EVALUATION OF THE SUITABILITY OF THE WIPP SITE

Environmental Evaluation Group  
Environmental Improvement Division  
Health and Environment Department  
State of New Mexico

May 1983

Figure 25. Particle flow path estimates 1983 in the vicinity of the WIPP site. Major chemical constituents of the Culebra water are indicated (based on Gonzalez, 1983)

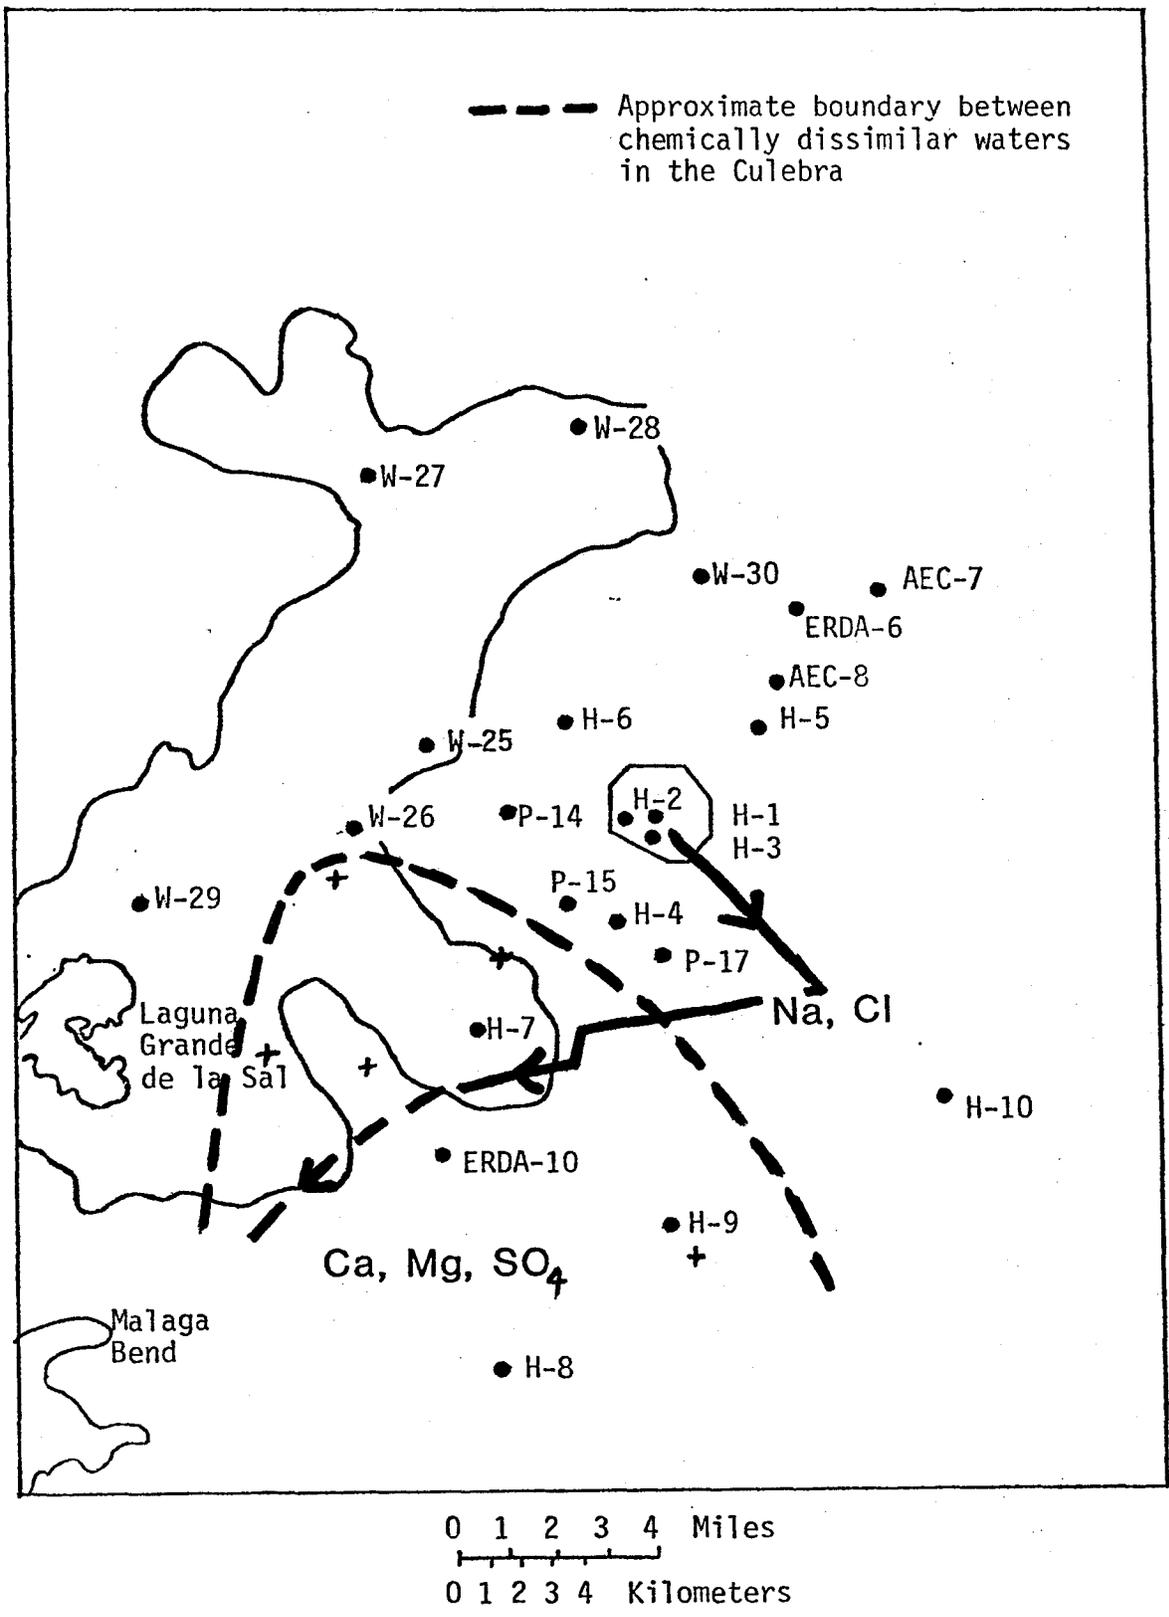
The potentiometric surface map of the Culebra is presented in Figure 18. From these data one might conclude that the direction of flow from the site is due south to about the center of T 23S, R. 31E, and then southwest to a discharge point at Malaga Bend. Recent work by Gonzalez (1983) to define the anisotropy of hydraulic conductivity (Figure 25) has led to the conclusion by DOE that the flow from the site will be southeast and then westerly to Malaga Bend. The decrease in TDS and the change in water chemistry from sodium and chloride to calcium, magnesium and sulfate south of the site has been discussed in the Regional Hydrology section. Until the chemical inconsistencies are explained, the hydraulic head distribution shown in Figure 18 does not definitively show that the direction of groundwater flow is other than along a straight line to Malaga Bend. To date, the anisotropy of conductivity has been determined at only three locations; H-4, H-5, and H-6. The direction of the principal component of the transmissivity tensor is nearly identical at test pads H-5 and H-6. At H-4, the direction of the principal component of the transmissivity tensor is rotated about 50° counterclockwise in relation to H-5 and H-6. No data on anisotropy are available at the center of the site or to the southeast. Additional anisotropy tests are needed to accurately predict the direction of groundwater flow in the fractured Culebra Dolomite.

Groundwater flow in the Culebra through fractures (Gonzalez, 1983; Weart, 1983; Mercer, 1983) is dramatically displayed by the H-6 tracer test. The three well configuration (labeled a, b and c) was an equilateral triangle, 100 feet on each side, with pumping from well "c" and tracer injection into the other two. The peak concentration in the b-c direction was 10 times greater and arrived 30 times faster than the peak concentration in the a-c direction. As the hydraulic conductivity in the b-c direction is at most 2.1 times greater than the hydraulic conductivity in the a-c direction, the travel time differences were attributed to differences in effective porosity. This assumption implies an equal flow path length, but this may be a poor assumption in fractured media.

The lack of anisotropy data at the site severely limits the confidence one can place in any model results. In fractured media, such as the Culebra, the hydraulic gradient does not necessarily indicate the direction of groundwater flow. In fact, the flow direction could be nearly parallel to the hydraulic head contours. The unexplained decrease in TDS and a change in the general chemical nature of the Culebra water from sodium and chloride at the site to magnesium, calcium, and sulfate south of the site indicates that insufficient data are presently available to adequately characterize the flow system south of the site. The anisotropy of hydraulic conductivity at the site must be determined before the flow direction can be postulated. The tracer tests provide information on the transport of conservative solutes, but these tests generate artificial flow systems. In fractured media, these tracer tests may not provide the proper data to use in modeling the transport of water and solutes in a natural flow system. However, the tracer tests are the only means currently available to estimate the solute transport parameters in a reasonable amount of time.
